Pre-Inspection Mezzanine Walkthrough Checklist

NEW ELECTRONIC PAY PROGRAM (NEPP) IN METRORAIL STATIONS
 NAYLOR ROAD
 KIOSK - POWER

Pre-Inspection Field
Verification 10/2/2014

SCALE AS SHOWN DRAWING NO. F09-E-101

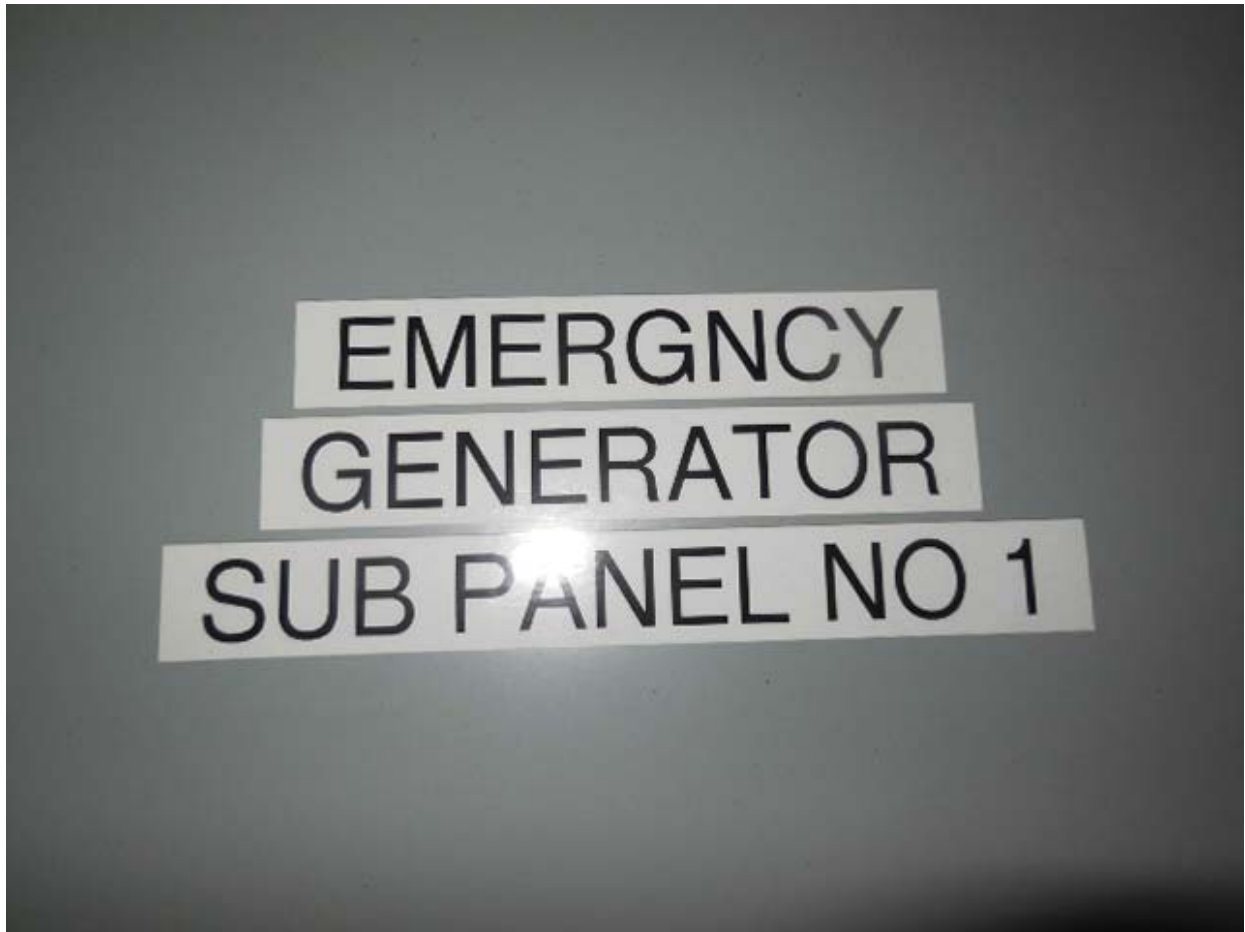
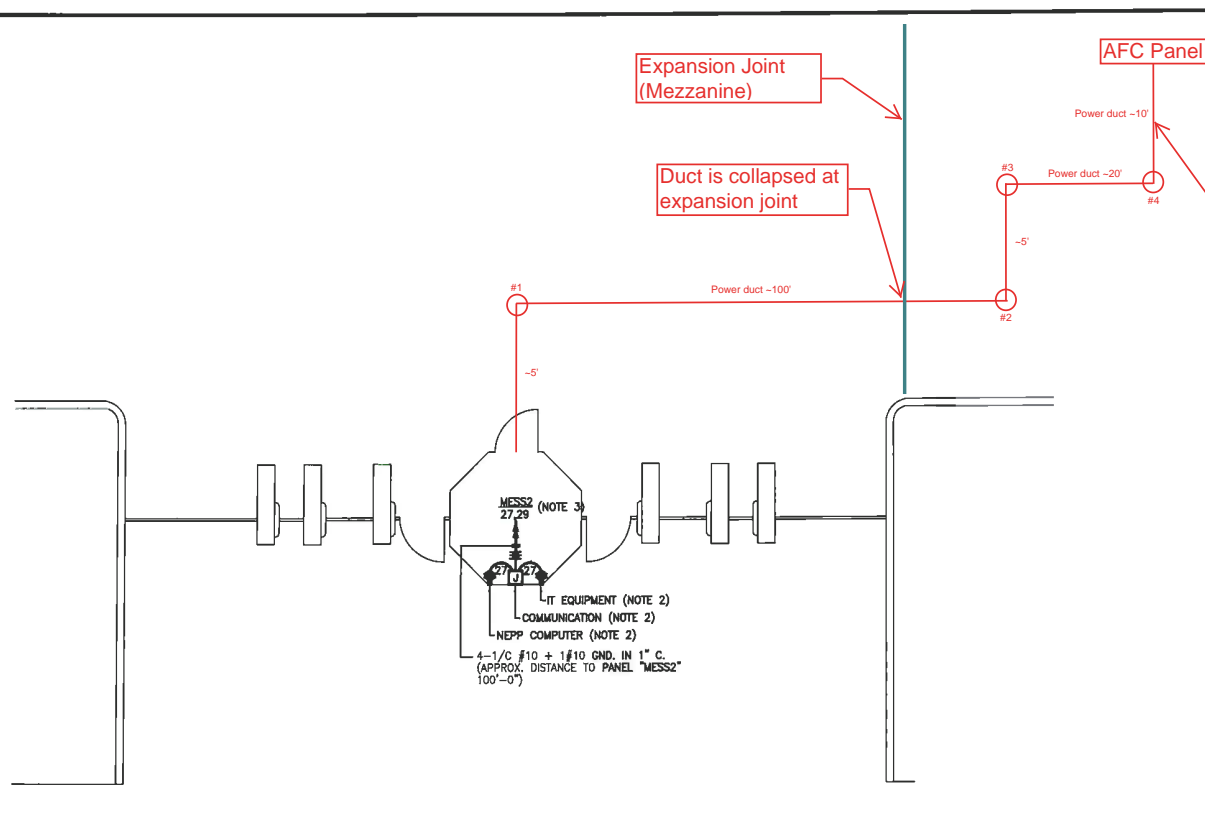
<input checked="" type="checkbox"/>	Verification of Kiosk Emergency Panel(s) (KE, KES, KESS, etc)	Source Panel Name/Number: EE Source Breaker Name/Number: Breaker #1 & #3 Panel Name/Number: Kiosk Emergency Power	Kiosk	
Notes and Discrepancies: Panel KE (Breaker #10) in Kiosk de-energizes emergency power to faregates.				
Sign Off	GFP Representative	WMATA PRGM		
Name:	Tino Sahoo			
Signature:				
Date:	10/02/2014

SCALE: NOT TO SCALE
DRAWING NO.: F09-E-102

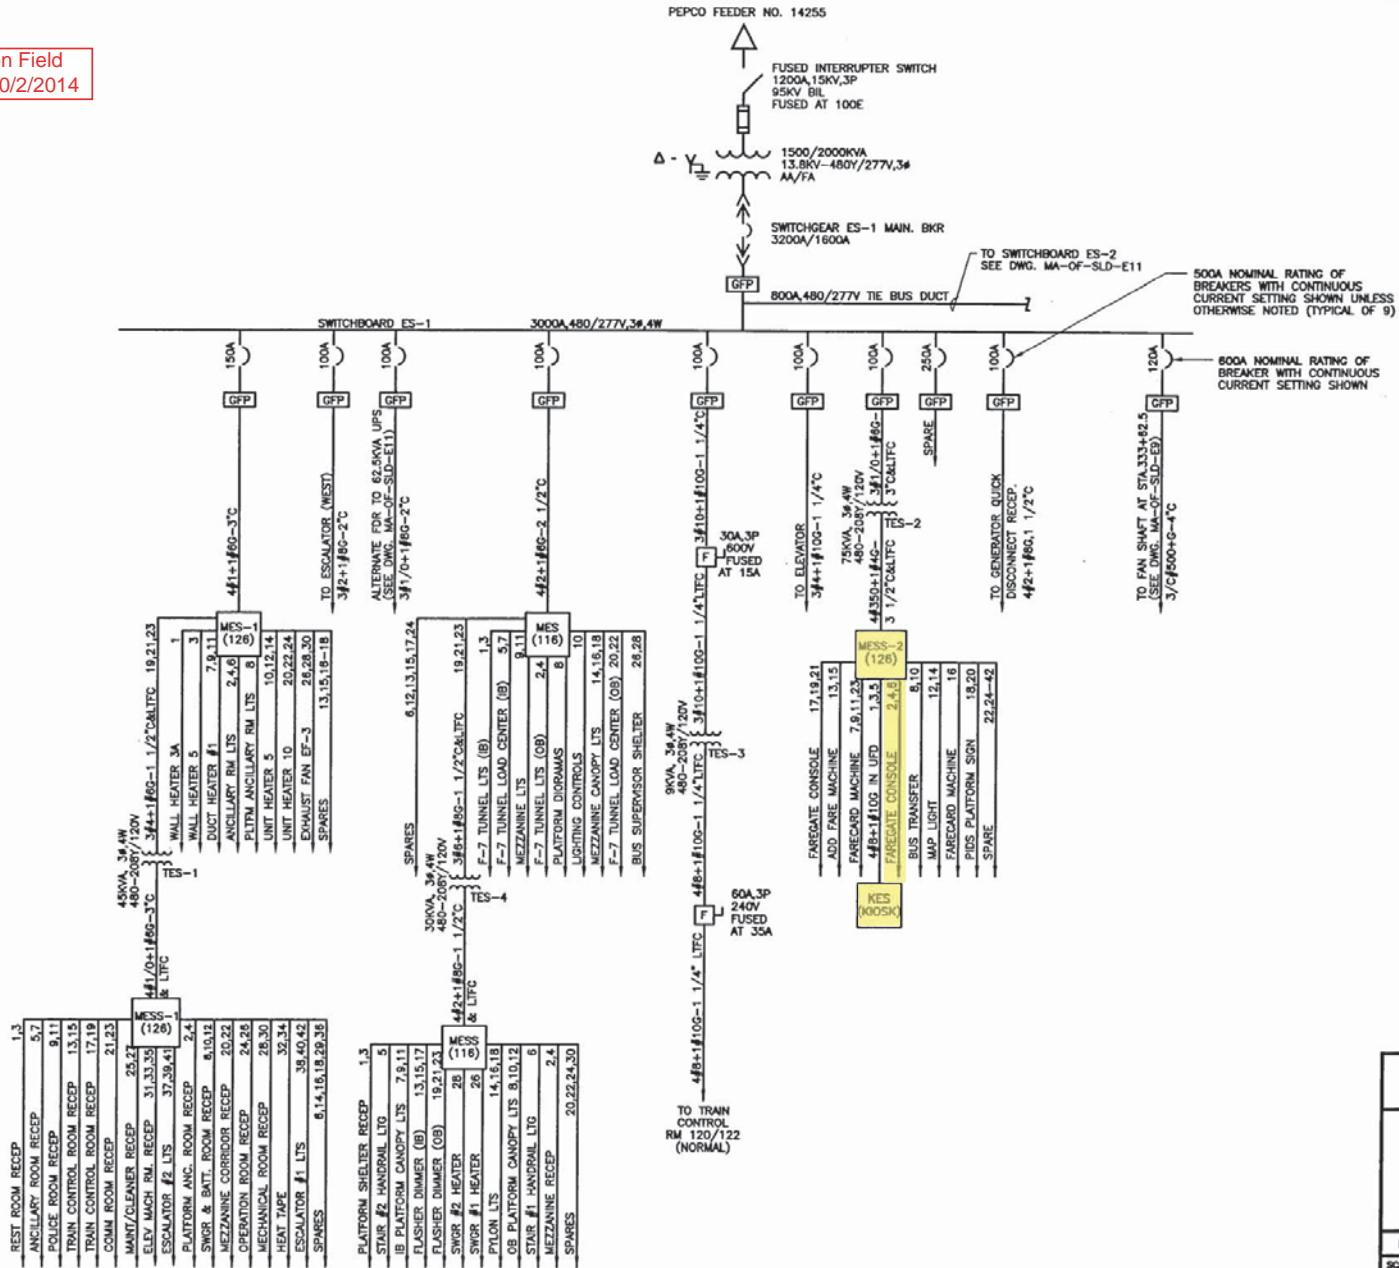
✓ 1
✓ 1&2

NOTES: A. EXISTING PANEL "MESS2" IS FED FROM 277/480V, 3Ø, 4W EXISTING "EMERGENCY GENERATOR SUB PANEL 1" LOCATED IN AC SWBD ROOM 116, CIRCUIT (#6)-100/3P VIA 75KVA TRANSFORMER (SEE ATTACHED DWG. MA-0F-SLD-E10).
B. ALL EXISTING WIRING FED FROM BOTTOM OF PANEL BY:
* 2-6" x 1-1/2" FLOOR DUCT (WIRING FILL >40%).
* 1-4" C. TO TRANSFORMER (WIRING FILL >40%).
* 1-3/4" C. (WIRING FILL >40%).

Pre-Inspection Field
Verification 10/2/2014
